Overview: Production error in version 1.0 harnesses; The immobilizer wire (orange/black) is in pin position #4 instead of pin position #5. Although an effort to correct the issue was made, some quantity of harnesses did get shipped before the issue was spotted. We are advising to inspect the harness BLADE connector before attempting to install harness or program the module. This issue is not known to affect the version 2 harnesses, which require no modification.

MODIFICACIÓN REQUERIDA PARA APLICACIONES A/T, SÓLO CON ARNÉS v 1.0

FTI-STP1: Notas de instalación y configuración

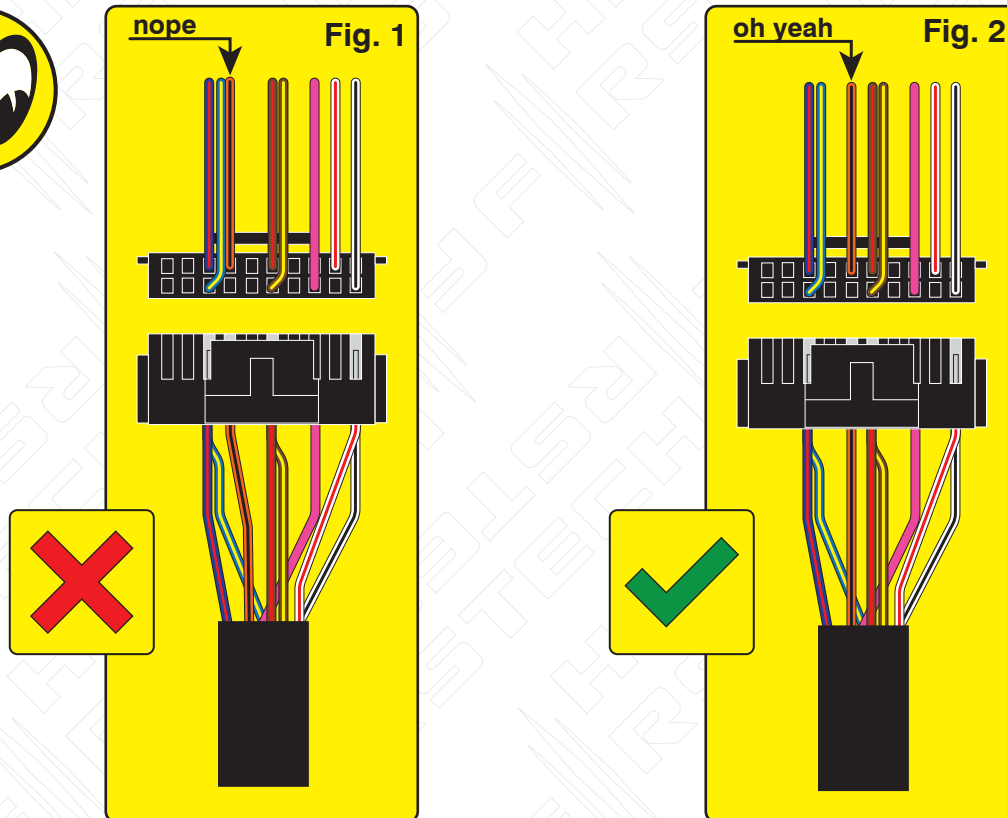
Issue: Module fails to program correctly to vehicle, does not allow the vehicle to be remote started.

Correction: Step 1.) Locate the orange/black wire and confirm whether it is positioned as illustrated in Fig. 1 or Fig. 2. If the wire is as illustrated in Fig.1, proceed with Step 2 through 5 and complete the repair procedure outlined, if the wire is as illustrated in Fig. 2, correction is not necessary, proceed with harness installation and module programming.

Step 2.) Using a pick, lightly depress the catch that secures the terminal in the housing then remove the wire and terminal from the housing.

Step 3.) Using a fine tip razor or utility knife, insert the blade beneath the terminal catch and raise it slightly, so that it can be reused to secure the terminal when reinserted into the BLADE connector housing.

Step 4.) Refer to Fig. 2 for correct position of the orange/black wire (next to brown/red) then reinsert the terminal, pressing lightly until the catch 'snaps' into place, securing the terminal in the connector housing.

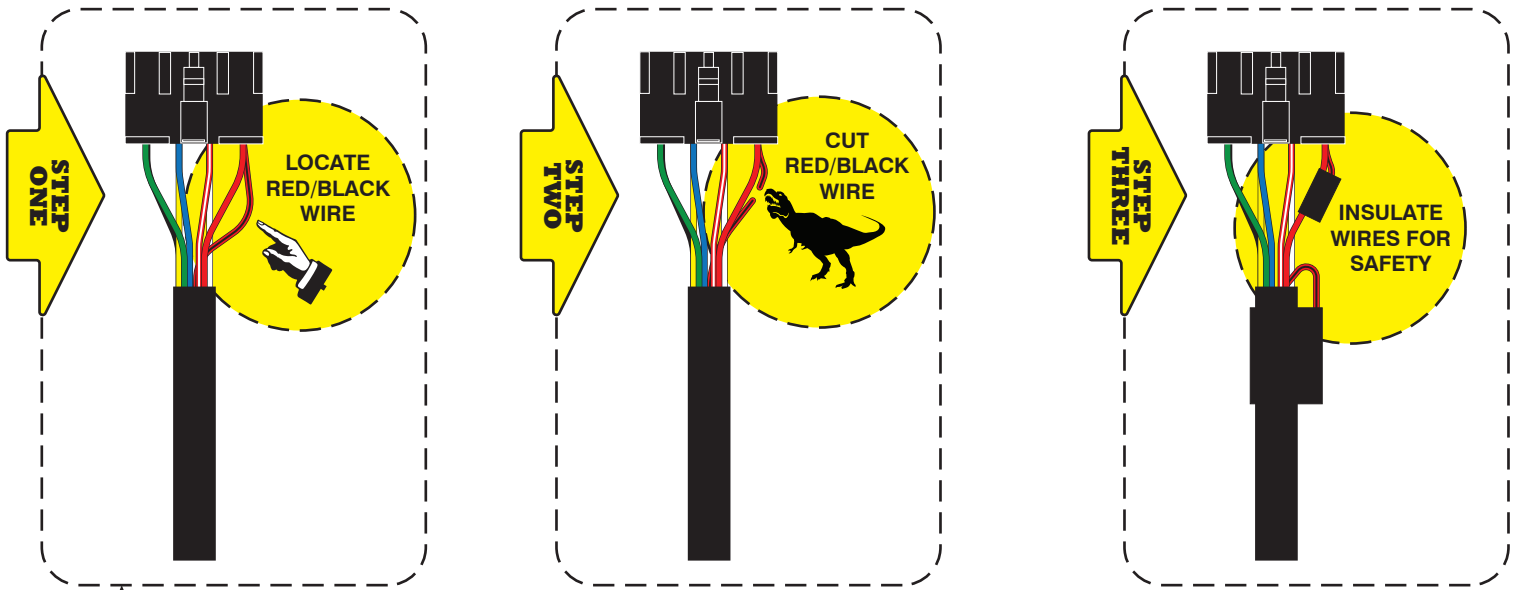
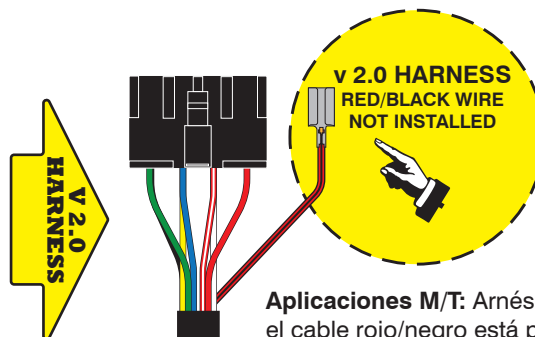
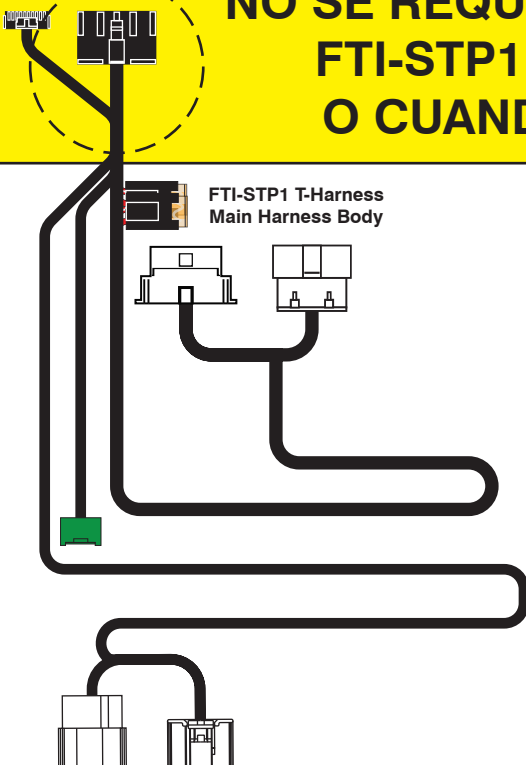
Descripción general: Las primeras versiones del arnés FTI-STP1 requieren modificaciones para aplicaciones de transmisión automática (AT), algunas del producto se pudo modificar antes del lanzamiento, pero una pequeña cantidad se lanzó sin modificaciones.

Problema: El arnés en T FTI-STP1 ha sido diseñado para ser compatible con A/T (transmisión automática) y M/T (manual), pero debido a un descuido en las primeras ejecuciones de producción, la selección se estableció por defecto en el modo M/T.

El uso de un arnés configurado para una aplicación M/T, en un vehículo equipado con A/T, podría provocar daños en el módulo del vehículo, se recomienda que el arnés vuelva al modo A/T antes de la instalación en vehículos equipados con transmisión automática.

Corrección: Localice el cable rojo/negro (+ embrague) proporcionado en el conector CN1 del conjunto del arnés principal. Corte el cable rojo/negro, ya sea al ras del conector CN1 o dejando suficiente cable expuesto para que pueda aislar y asegure los extremos del cable que quedan después del corte. Aísle cada uno de los extremos restantes del cable rojo/negro y asegúrelos para evitar cualquier posibilidad de cortocircuito. Si el cable rojo/negro ya ha sido desconectado, ninguna modificación adicional se requiere para aplicaciones A/T

NO SE REQUIERE MODIFICACIÓN CUANDO SE UTILIZA FTI-STP1 (v 1.0) ARNÉS EN APLICACIONES M/T, O CUANDO UTILICE EL ARNÉS FTI-STP1 (v 2.0)

Aplicaciones M/T: Arnés versión 2.0, el cable rojo/negro está pegado al arnés principal cuando se envía, y debe instalarse en el CN1 conector cuando está instalado.

Aplicaciones A/T: Deje el cable rojo/negro pegado al arnés, no es necesario para aplicaciones A/T
